ADDENDUM NUMBER TWO

100% Construction Documents (Dated 11.04.22)

Date: **December 21, 2022**

Project: **Sandia Base Elementary School**

1 HVAC LEVEL 1 FLOOR PLAN - AREA B
 1/8" = 1'-0"

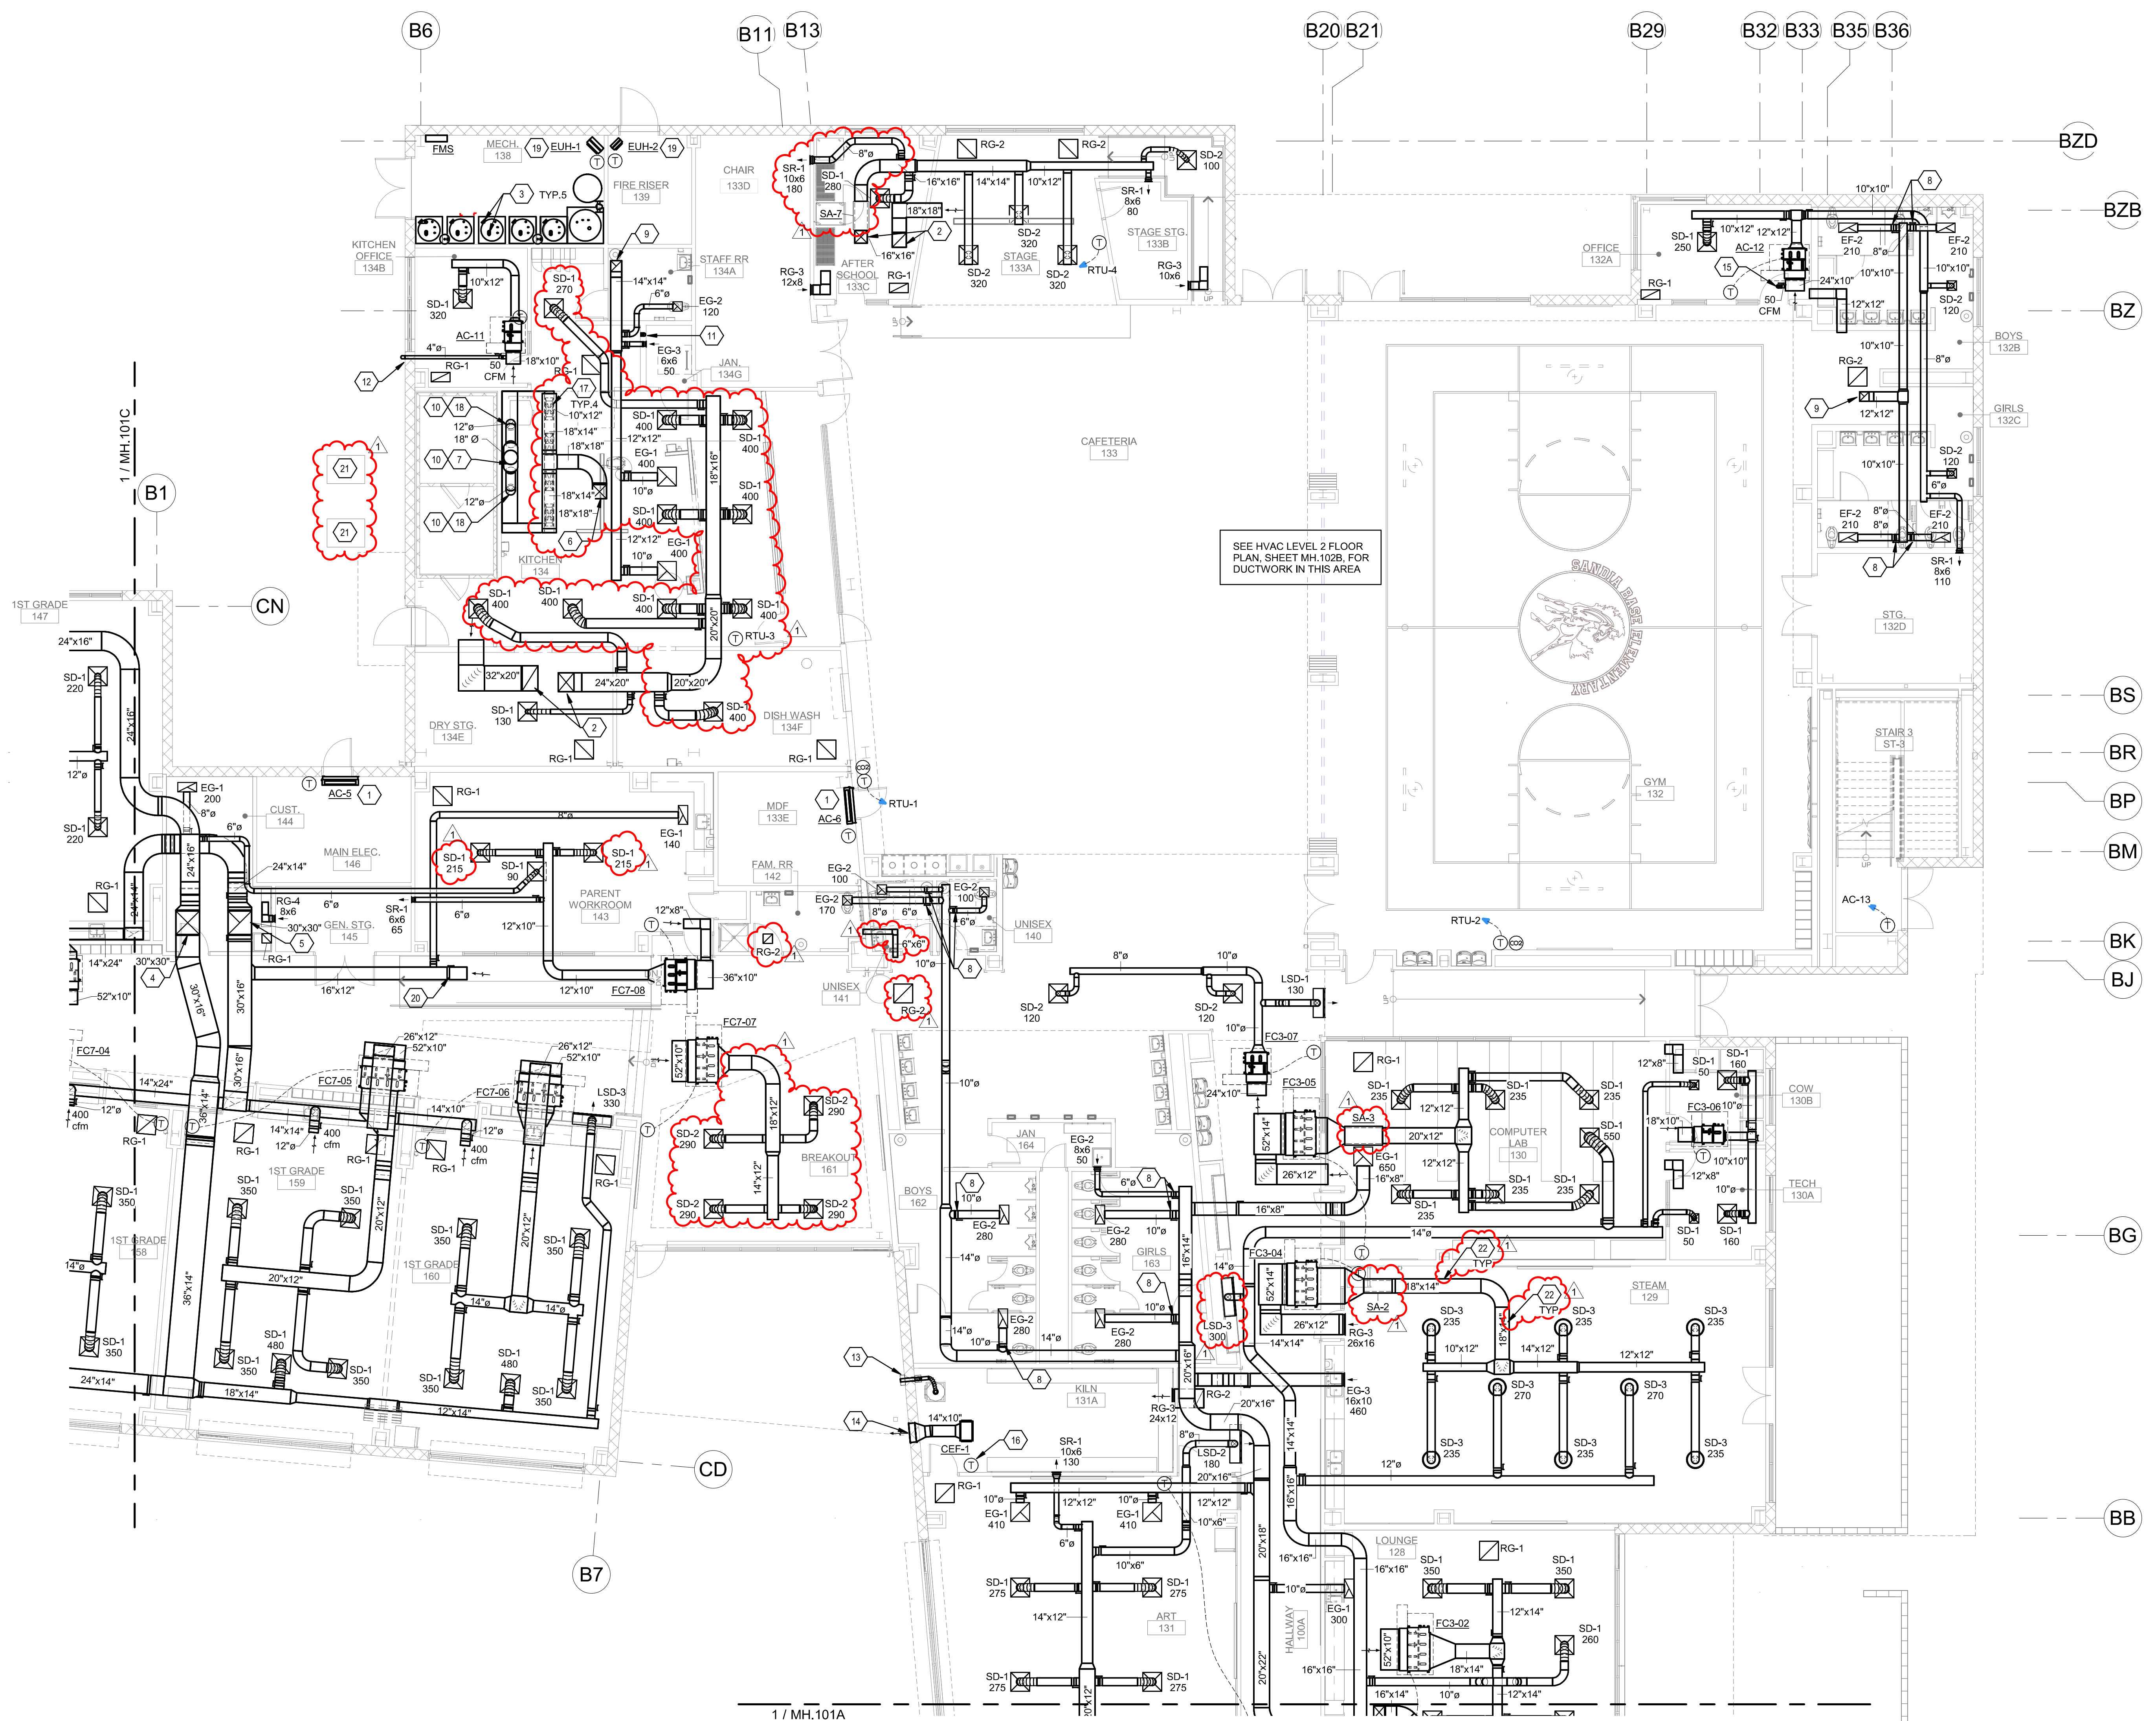
7. **MODIFY** exhaust duct sizes and cfm values in Nurse's Suite.
2. Sheet MH.101B – HVAC LEVEL 1 FLOOR PLAN – AREA B
 1. **ADD** sound attenuator, SA-2, to FC3-04 supply duct.

2. **ADD** sound attenuator, SA-3, to FC3-05 supply duct.
 3. **MODIFY** duct sizes and cfm values for FC7-07.
 4. **MODIFY** cfm values for FC7-08.
 5. **MODIFY** cfm in 100A Hallway.

6. **ADD** return grille to 142 Family RR, 100B Hallway.
 7. **ADD** transfer duct to 141 Unisex.
 8. **MODIFY** duct sizes and cfm values for RTU-3.
 9. **ADD** duct sizes to kitchen hood make-up air duct.

10. **ADD** keyed note 21 to cooler/freezer condensing units.
 11. **ADD** keyed note 22 to exposed rectangular duct in 129 STEAM.
 12. **ADD** keyed note 21 and 22.

13. **ADD** sound attenuator, SA-7, to RTU-4 supply duct
 14. **REROUTE** supply duct to 133D Chair.
3. Sheet MH.102A – HVAC LEVEL 2 FLOOR PLAN – AREA A

1 HVAC LEVEL 2 FLOOR PLAN - AREA A
1/8" = 1'-0"

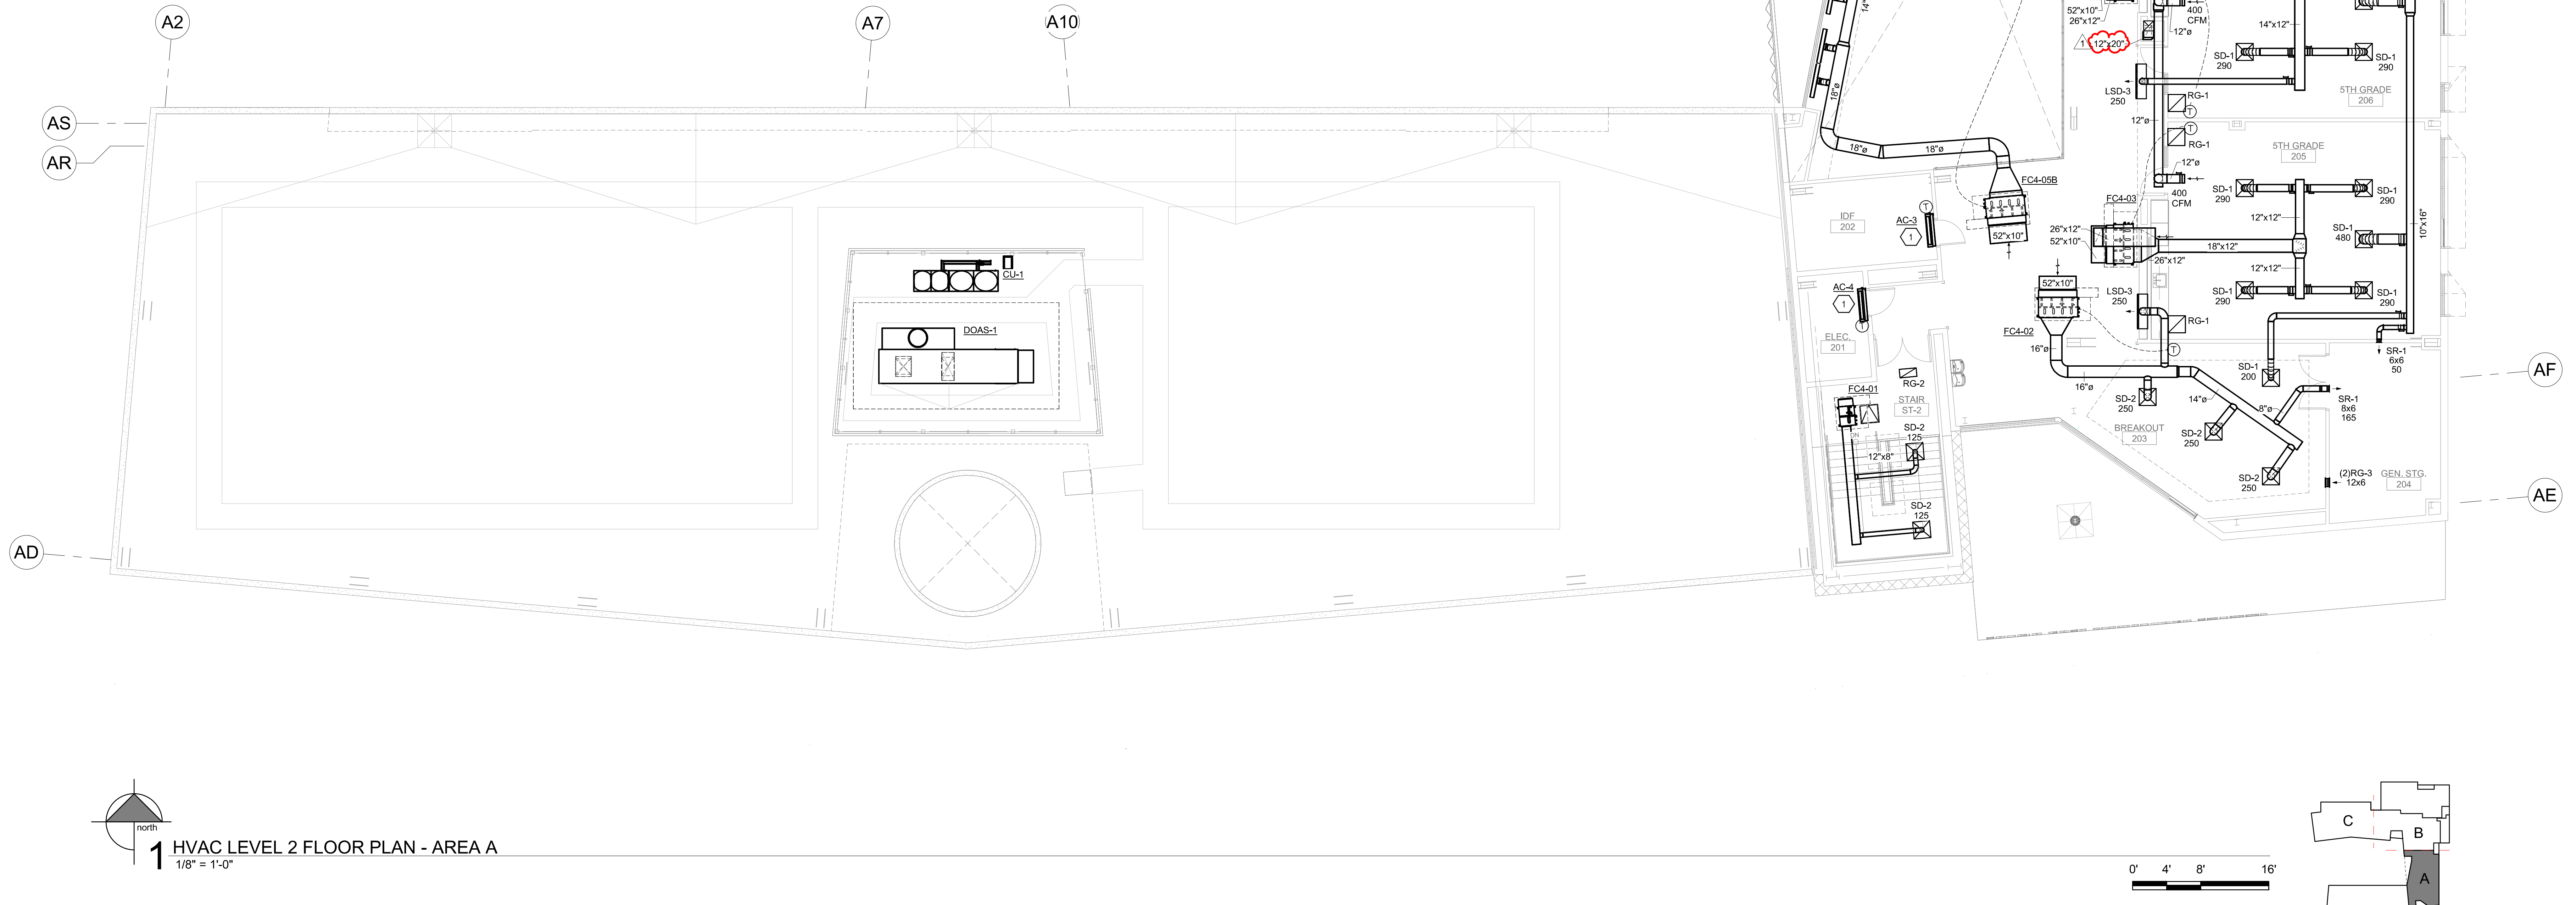
1. **ADD** sound attenuator, SA-4, to FC5-01 supply duct.
 2. **MODIFY** outside air cfm for 209 Copy Room.
 3. **MODIFY** exhaust duct sizes.
4. Sheet MH.102B – HVAC LEVEL 2 FLOOR PLAN – AREA B

1 HVAC LEVEL 2 FLOOR PLAN - AREA B
 1/8" = 1'-0"

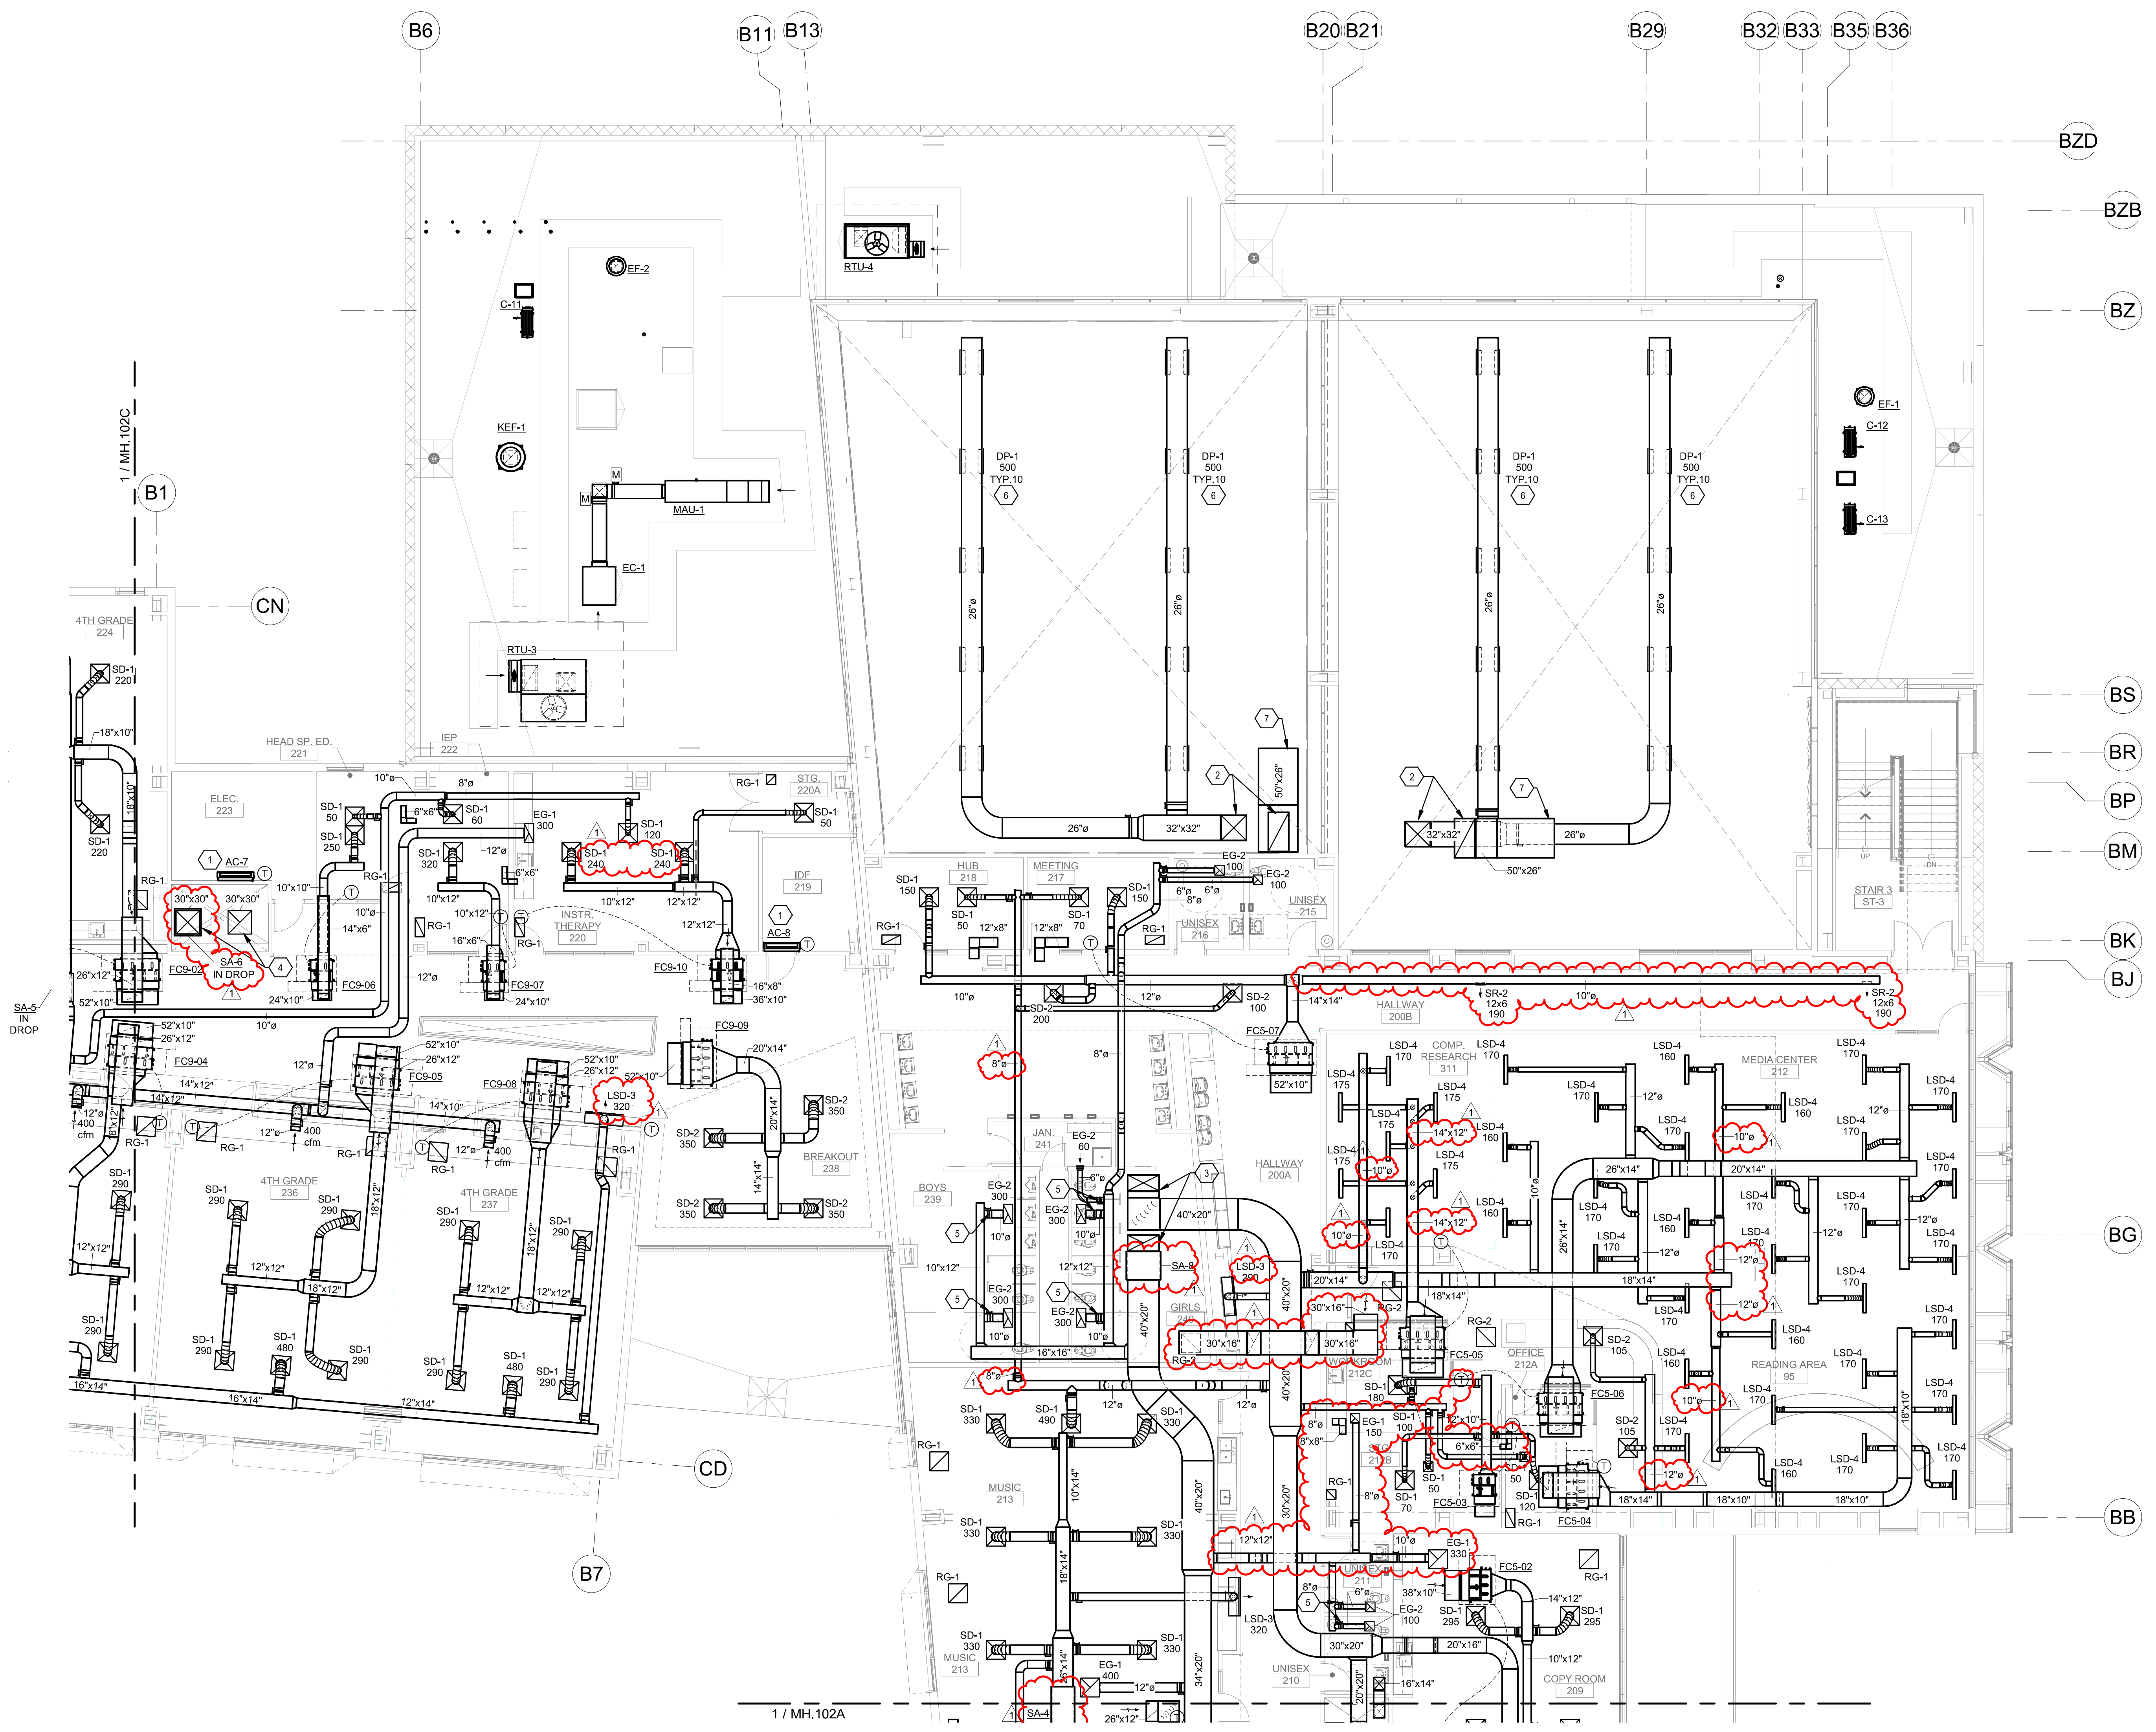
1. **ADD** sound attenuator, SA-8, to DOAS-2 exhaust duct.
 2. **RELOCATE** thermostat for FC5-06.
 3. **ADD** duct sizes in 212 Media Center.
 4. **MODIFY** duct size and cfm values for FC5-07.

5. **MODIFY** cfm values for FC9-10.
 6. **ADD** keyed note 7.

7. **MODIFY** cfm value in Breakout 238, 200A Hallway.
 8. **ADD** sound attenuator, SA-6, to DOAS-4 supply drop in chase.
 9. **MODIFY** exhaust duct from 212C Workroom and 209 Copy Room.

10. **ADD** transfer duct and grille from 212 Media Center to 240 Girls.
 11. **REROUTE** outside air duct to 212A Office.
 12. **ADD** transfer duct in 212C Workroom and 212A Office.
